PCN #: 2308 (REV 2)

PCN Title: Additional FAB Source and Assembly/Test Site on Select Devices

PRODUCT CHANGE NOTICE

PCN-2308 REV 2

Table 1 - Qualify Additional A/T Source (SAT) Diodes Incorporated / Shanghai, China with Au to Cu wire and BOM

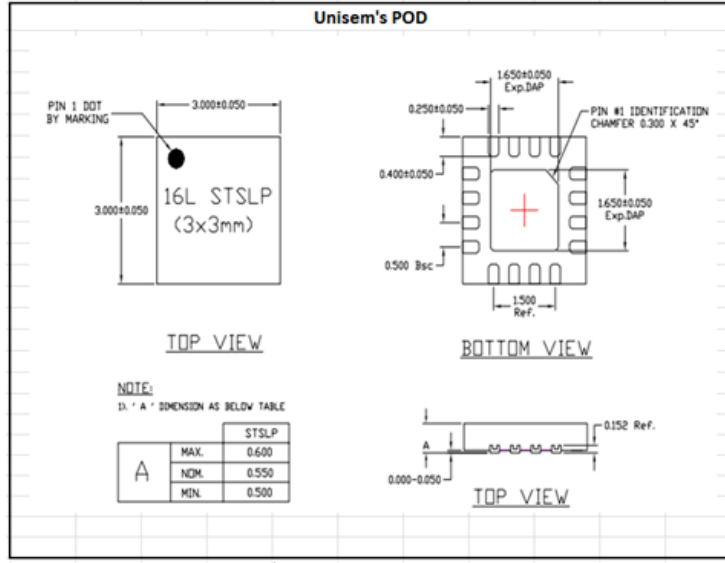
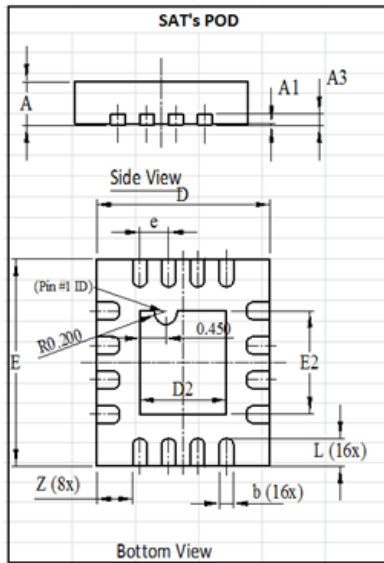
AP2112R5-1.2TRG1	AP2112R5-1.8TRG1	AP2112R5-2.5TRG1	AP2112R5-2.6TRG1	AP2112R5-3.3TRG1	AP2112R5A-1.2TRG1
AP2112R5A-1.8TRG1	AP2112R5A-2.5TRG1	AP2112R5A-2.6TRG1	AP2112R5A-3.3TRG1	AP2115R5-1.2TRG1	AP2115R5-1.8TRG1
AP2115R5-2.5TRG1	AP2115R5-3.3TRG1	AP2115R5A-1.2TRG1	AP2115R5A-1.8TRG1	AP2115R5A-2.5TRG1	AP2115R5A-3.3TRG1
